GEOSHIELD Verification Report

REPORT NUMBER: Justification

PROJECT: Signature Homes - Holmfirth

This report explains why Plots 14-21 have been signed off and verified.

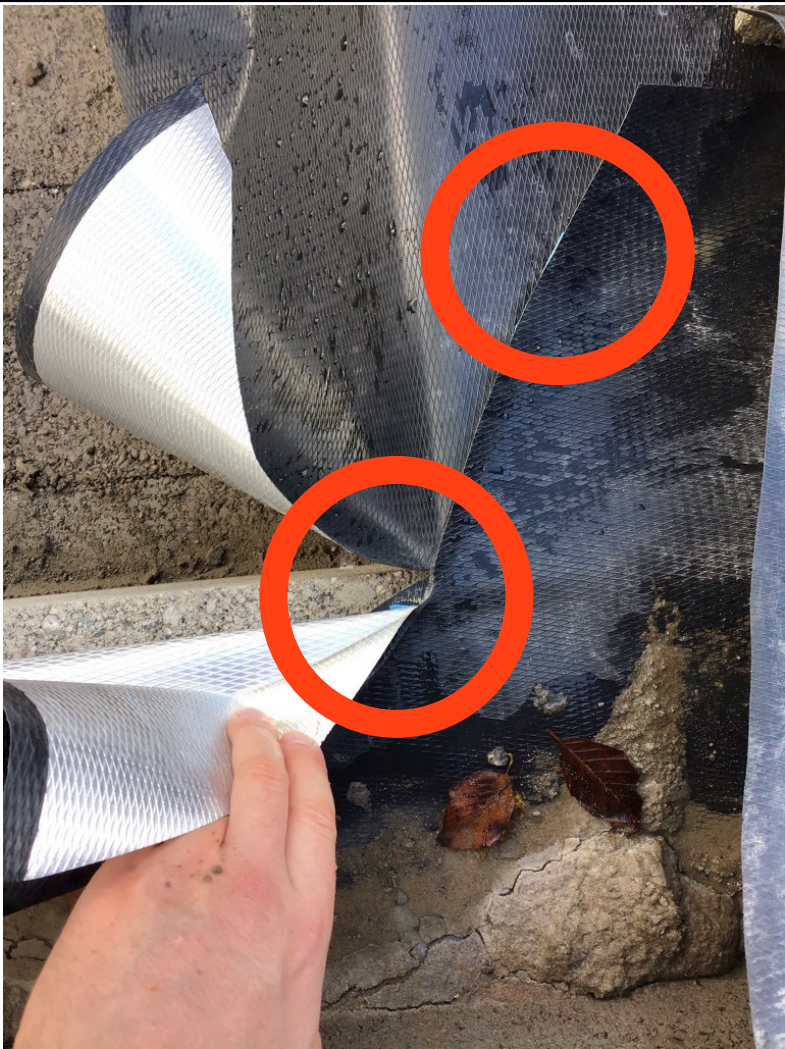
RESTRICTIONS AND LIMITATIONS: There has been some confusion with regards the sign off of Plots 14-21 perimeters. The verifier was new to the job and expressed some errors in the installation that were not all errors. Butyl tape was missing from the DPC cavity tray and door thresholds were sealed with the floor infill.

1. Image from Report 001 shows the DPC being used as the cavity tray. It states there is no double sided butyl tape in the cavity tray. It is not GR DPC because it's black on both sides. The GR DPC is lower in the wall.

2. Report 004. Door threshold not sealed but there is sufficient GR DPC to seal (circled)

VERIFICATION ITEM ONE

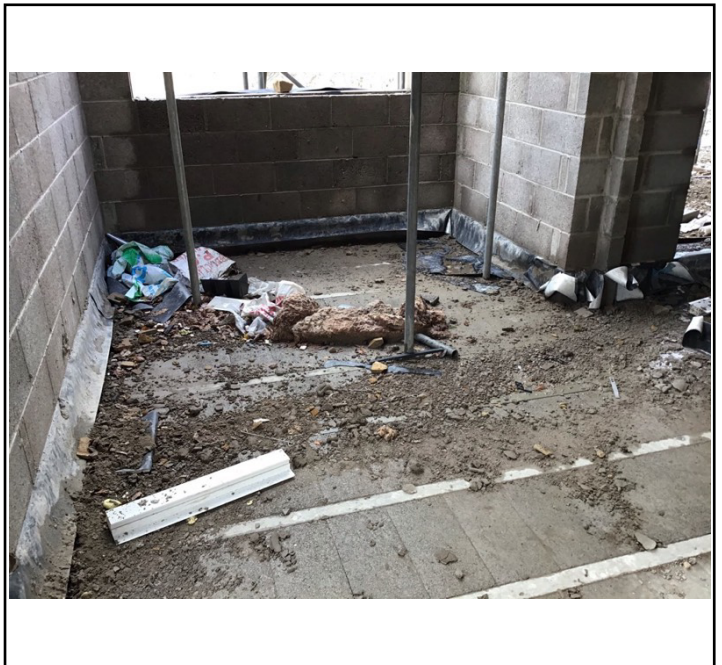
NOTES: The verifier was correct that corner details have not been

reinforced with GR SAM. This should have been carried out and verified prior to the

1. GR DPC tailed hanging out to form sufficient seal inside the building (Report 03).

2. Enough GR DPC extruding to form sealed corner detail (Report 04).

walls being built. On closer inspection, the joints were sealed with double sided butyl

tape so it was deemed sufficient to achieve sufficient seal from inside the property.

VERIFICATION ITEM ONE

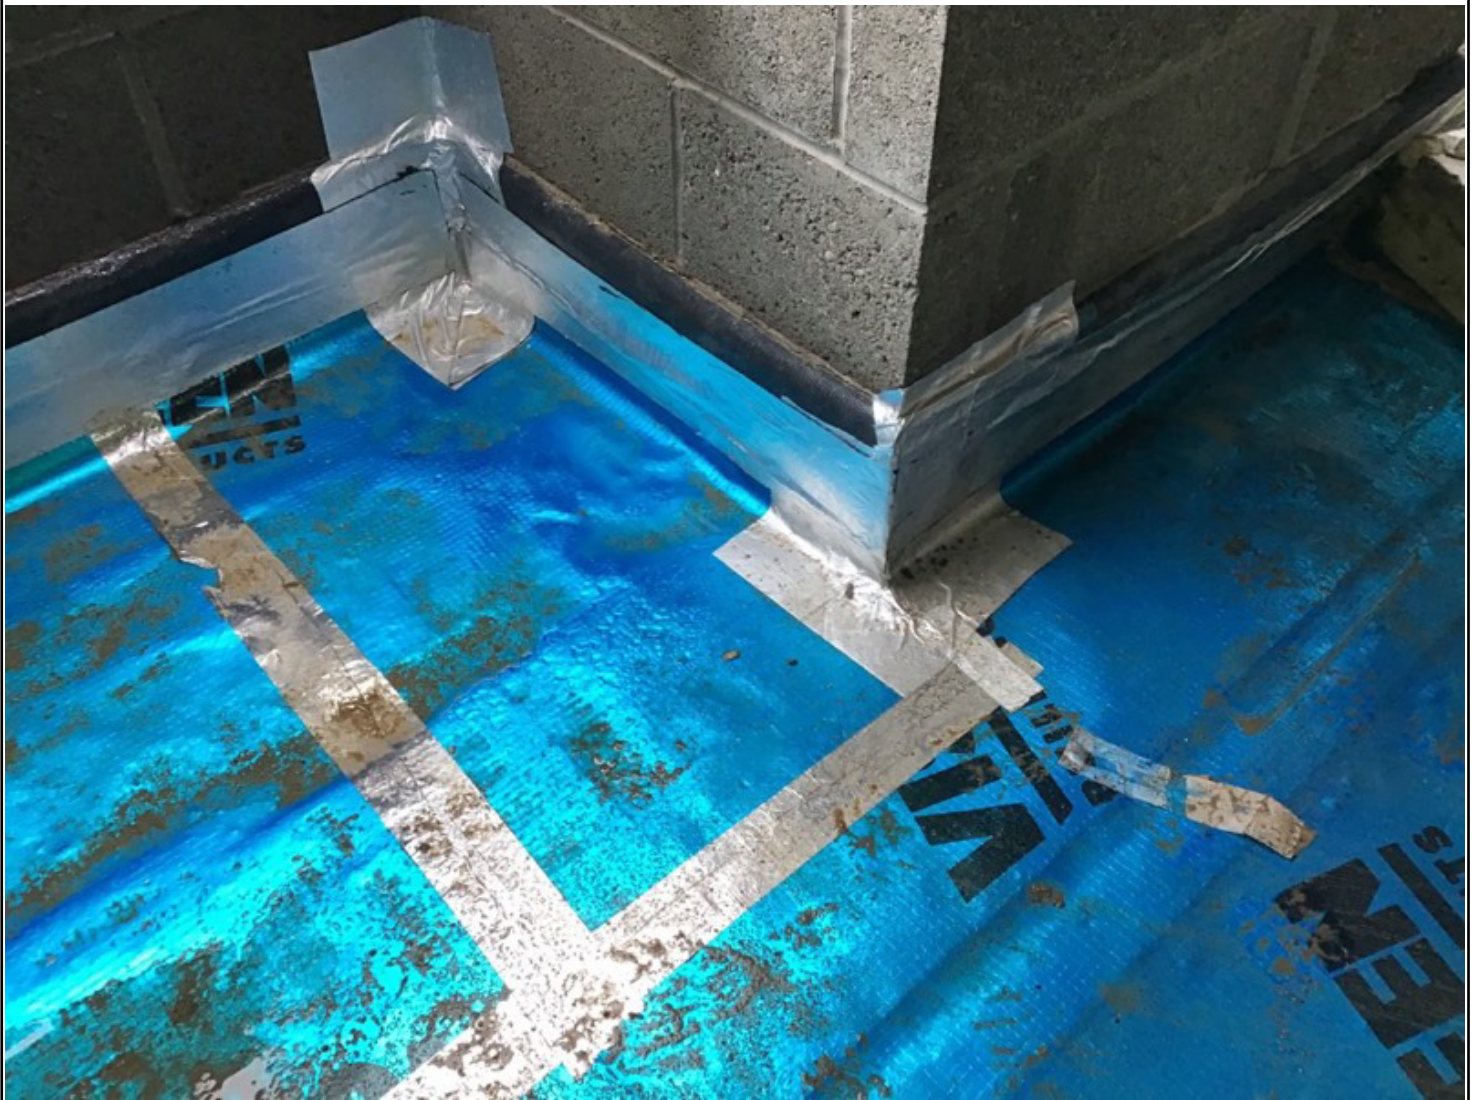
3. The corner details were not sealed with GR SAM as per NVQ Level 2. However,

butyl tape was installed in side the joints in the GR DPC running through the wall.

Geoshield confirmed the installation could be finished in accordance with CIRIA 795

and seal the corner details internally.

VERIFICATION ITEM TWO

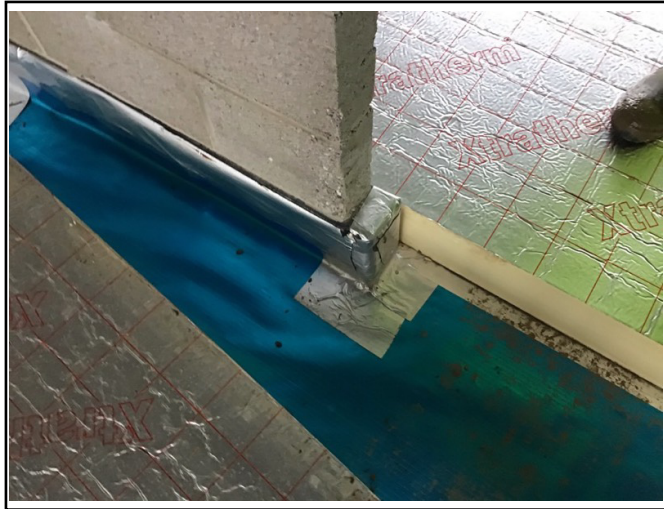
NOTES: Photos below show how the extruding GR DPC was

sealed from inside each property to form a suitable seal when combined with the

1. Example of corner detail sealed from inside the property.

2. Example of corner detail sealed from inside the property.

butyl tape inside the cavity wall. Geoshield have deemed this seal suitable and

sufficient for sign off.
